February 8, 1993

Docket No. 52-002

APPLICANT: ABB-Combustion Engineering, Inc. (ABB-CE)  
PROJECT: CE System 80+  
SUBJECT: PUBLIC MEETING OF JANUARY 11, 1993, TO DISCUSS THE REVIEW STATUS  
OF THE CE SYSTEM 80+ DESIGN WITH SENIOR MANAGEMENT

Figure 2

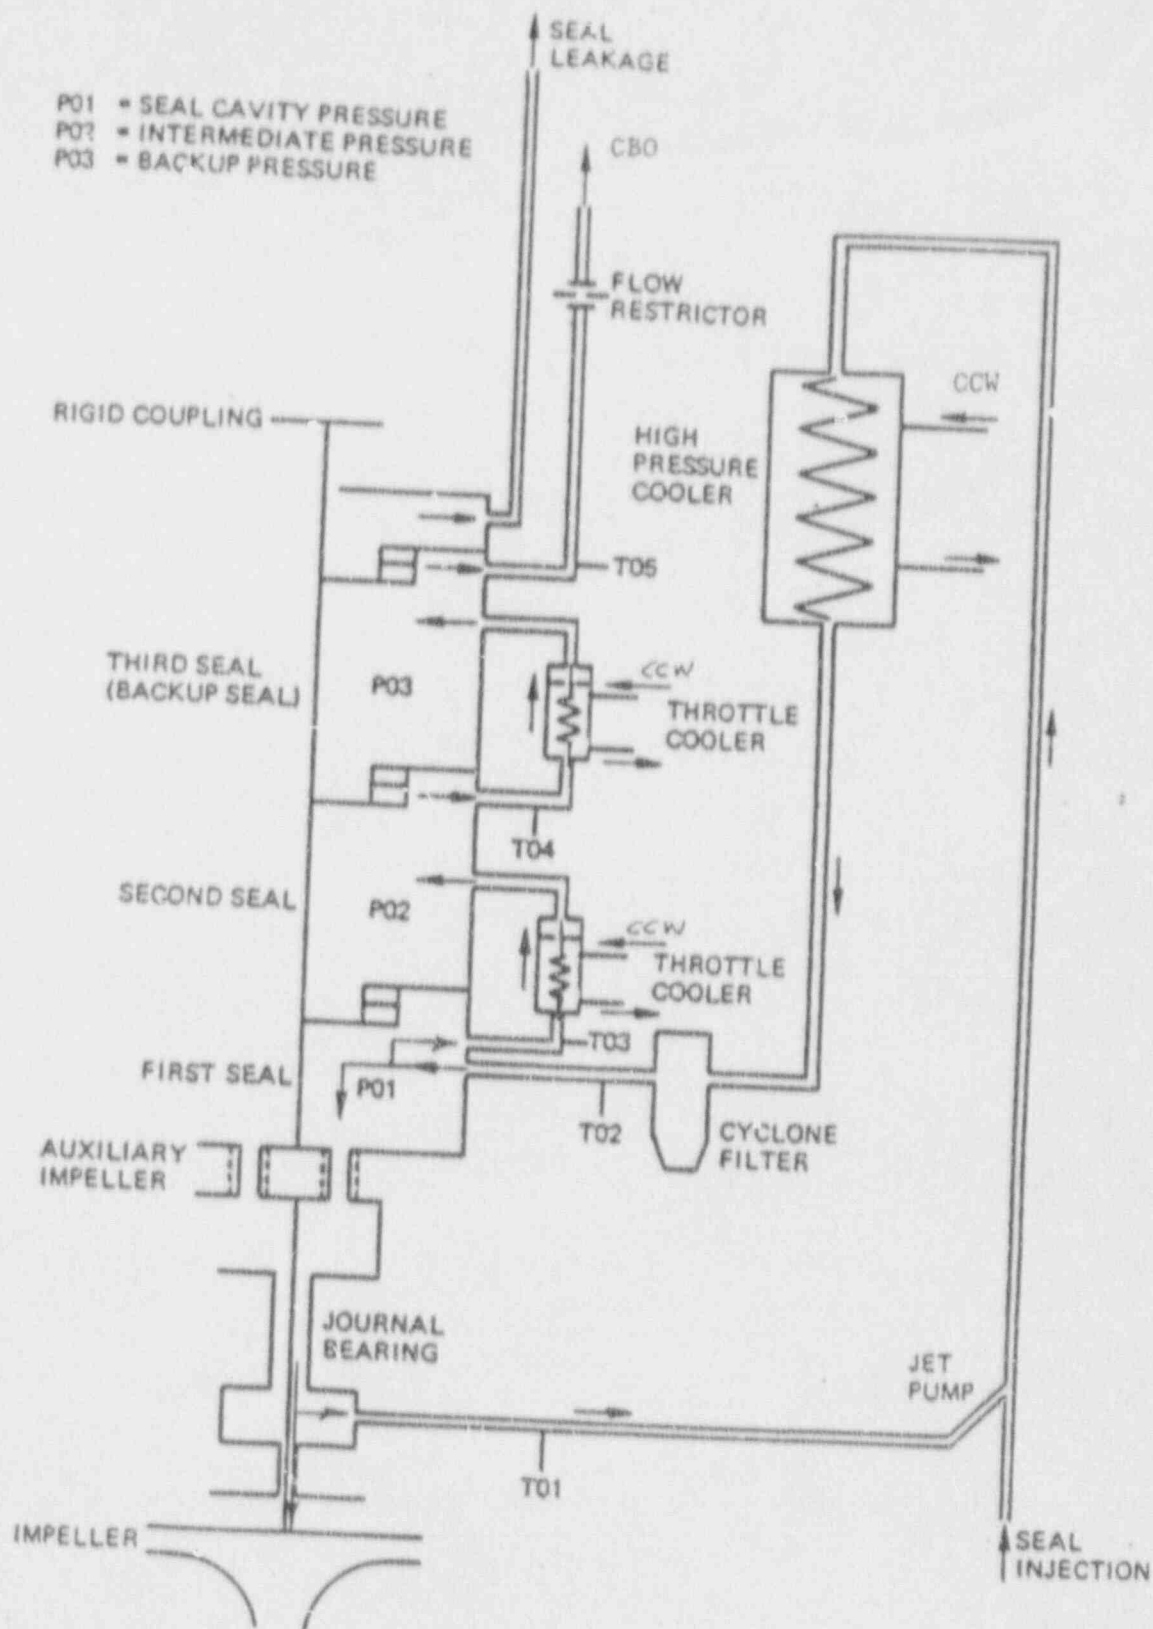
- o NRC DOES NOT AGREE WITH ABB-CE DESIGN APPROACH
- o ABB-CE DESIGN APPROACH HAS REDUNDANT MEANS OF COOLING THE REACTOR COOLANT PUMP SEALS
- o NRC WANTS A SEAL ASSEMBLY THAT WOULD NOT LEAK EXCESSIVELY DURING A STATION BLACK OUT. A SATISFACTORY RESOLUTION INVOLVES:

- o ABB-CE IS INVESTIGATING A DEMONSTRATION TEST, IF AGREEMENT TO THE TEST ACCEPTANCE CRITERIA CAN BE ACHIEVED WITH THE NRC
- o JANUARY 21, 1993, ABB-CE WILL BE MEETING WITH THE NRC STAFF TO DEFINE THE DEMONSTRATION TEST CRITERIA

# DIVERSE MANUAL ESF ACTUATION INTERFACE TO ESF COMPONENTS

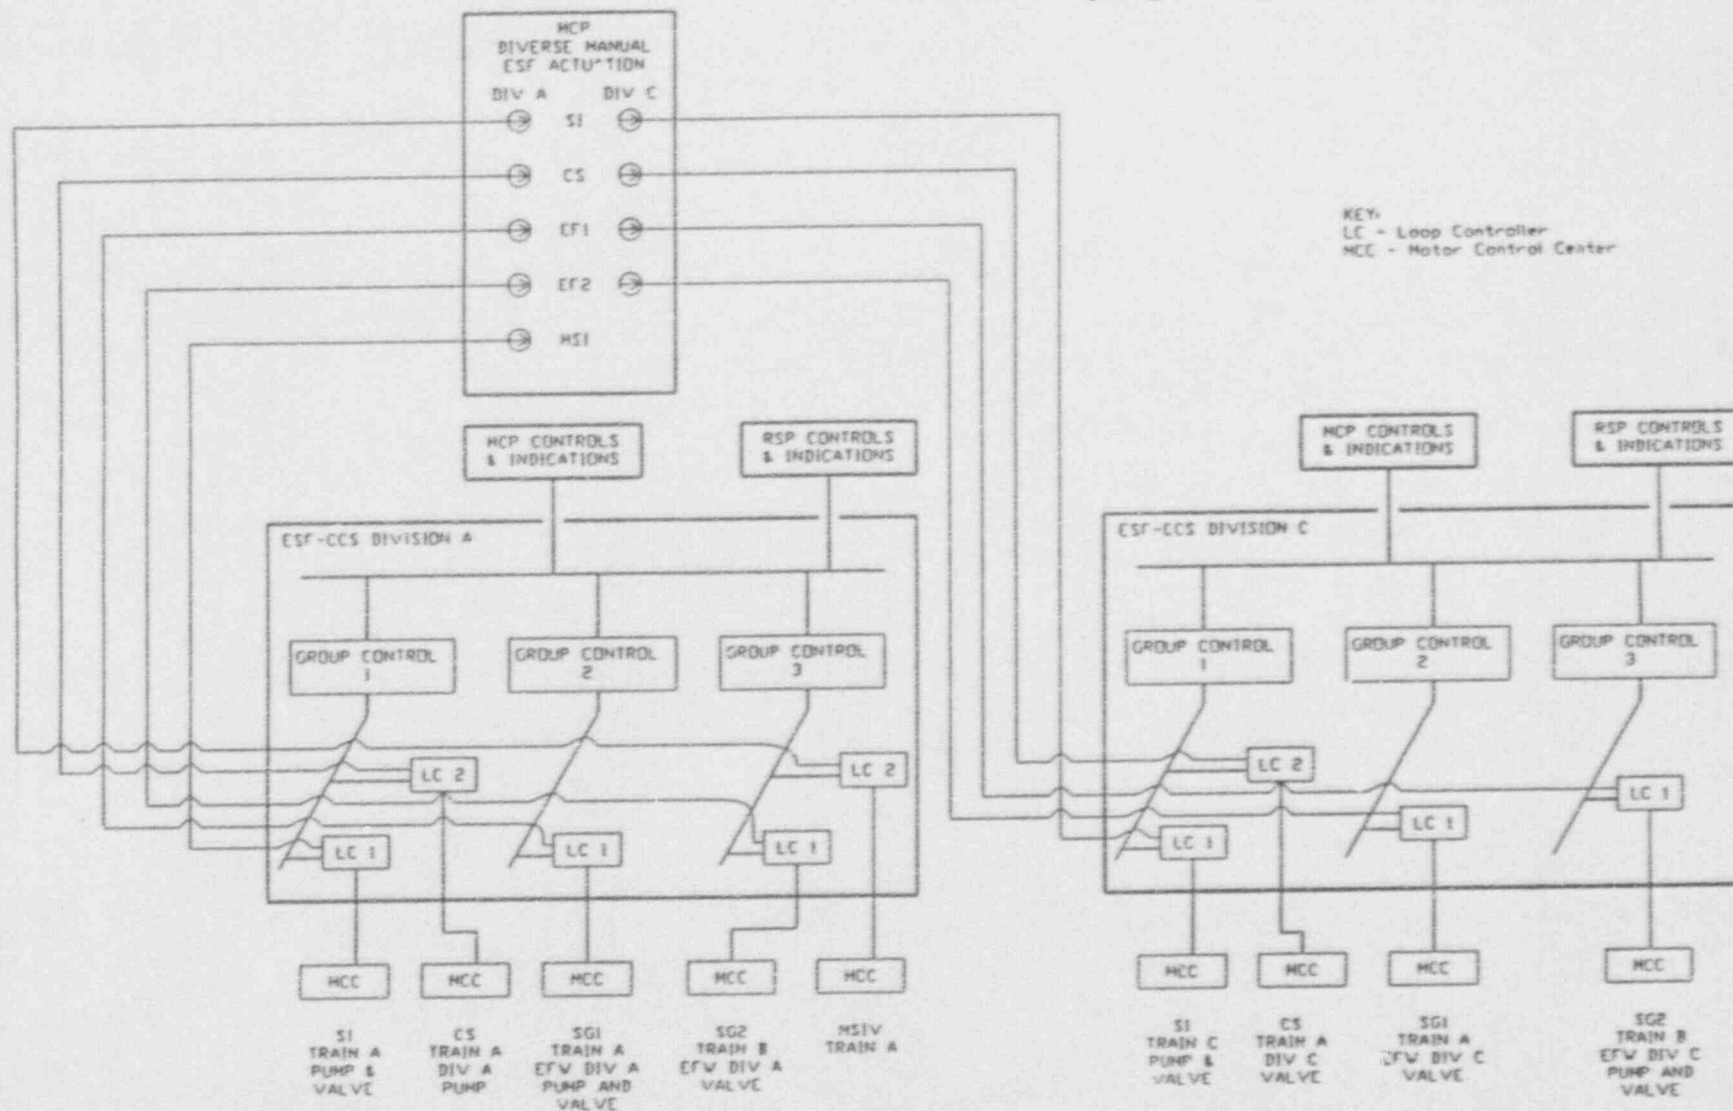
- 1) WORK WITH THE NRC STAFF TO ESTABLISH ADEQUACY OF DIVERSE SYSTEMS FOR ALL MODERATE AND INFREQUENT EVENT INITIATORS.
- 2) MITIGATION OF LIMITING FAULT EVENTS SHOULD BE VIA MANUAL ACTUATION OF ESF SYSTEMS USING CONTROLS IMPLEMENTED TO COMPLY WITH DEFENSE IN DEPTH POSITION 4.

- o MANUAL ACTUATION PROVIDED FOR 1 TRAIN OF EACH ESF PRIMARY FLOW PATH
- o CONTROL IMPLEMENTATION BYPASSES ALL MULTIPLEXING AND ALL COMPUTERS WITH LARGE SOFTWARE APPLICATIONS (I.E., HARDWIRED)

THE LAST PLC PROVIDING DIRECT CONTROL TO THE CONTROLLED COMPONENTS IS RETAINED.
